REPORT TO: Committee of Adjustment

REPORT NO.: DSD-2025-115

SUBJECT: Minor Variance Application A2025-021 – 2880 King Street East

Figure 2: Site Plan in Accordance with SPB24/097/K/AS

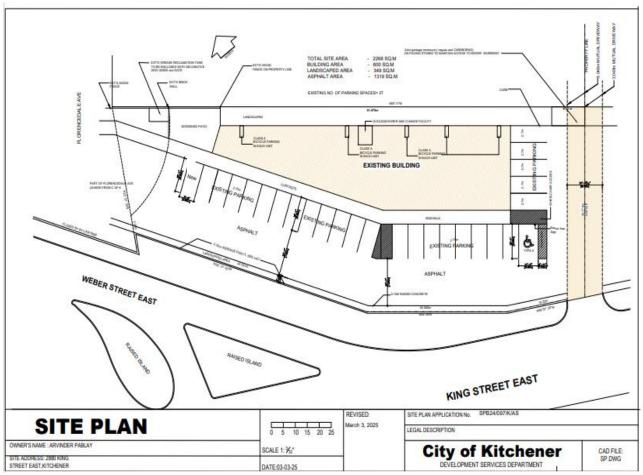
Due to site constraints, there is insufficient space to provide the required number of parking spaces required by Zoning By-law 2019-051 Section 5.6, table 5-5 (3) a. As a result of the increased parking requirement, due to the addition of a new restaurant use

and insufficient space, the applicant is seeking a minor variance to recognize the existing parking supply.

The applicant has submitted site plan application SPB24/097/K/AS and it is currently under review. Through the review of the Minor Variance Application, a Parking Justification Study has been requested by Transportation Services staff. The Site Plan Application will be put on hold until such time as the Minor Variance Application is considered.

In accordance with the comments of Transportation Services Staff below, Planning staff is recommending a deferral of Minor Variance Application A2025-021 for 6 months, or sooner, to allow the Applicant time to prepare a Parking Justification Study.

City Transportation Staff recommends a Parking Study is prepared by the Applicant to support the application. Based on a high-level internal review of expected parking demand, City Transportation Staff expect that the expected parking demand will be unable to be accommodated within the site and the demand may be greater than the by-law requirement.
